**Hanover Police Service
Hanover, ON**

ADDENDUM NO. 1

2026.08.24

AMENDMENT NO.2 – REVISIONS TO ARCHITECTURAL DRAWINGS

A2.01

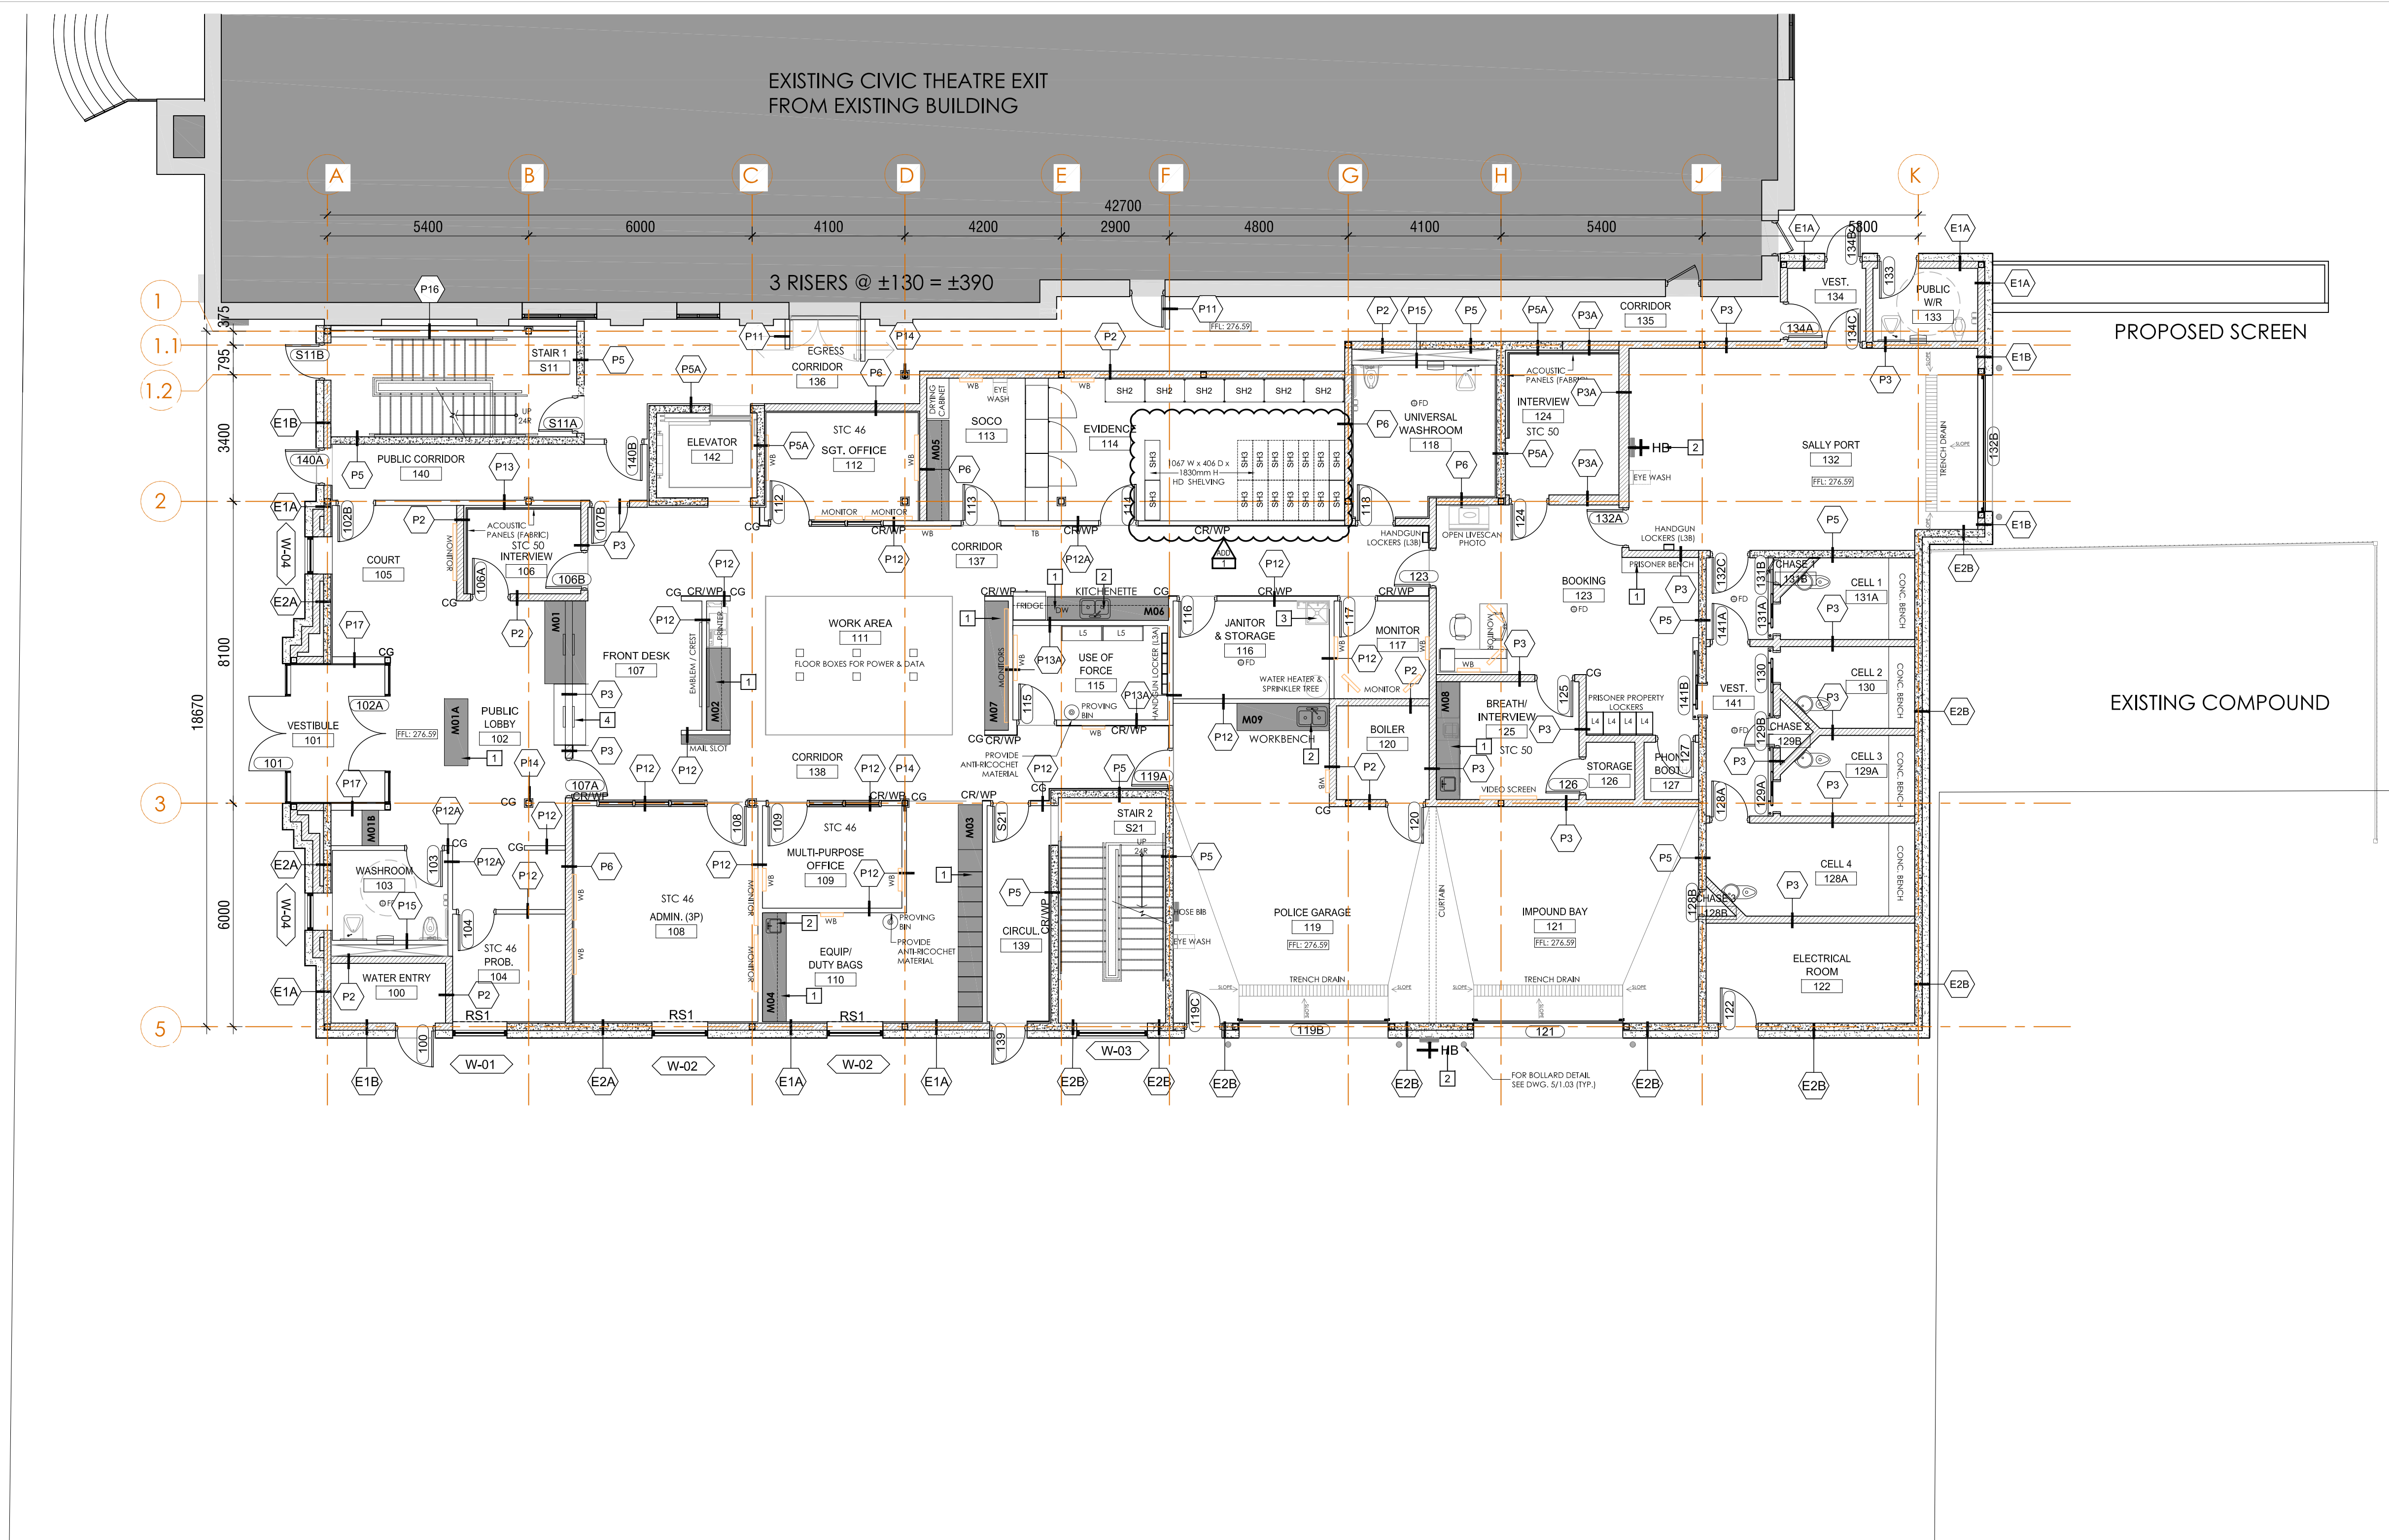
1. Refer to attached Drawings A2.01 and A2.06 for updated shelving layout.
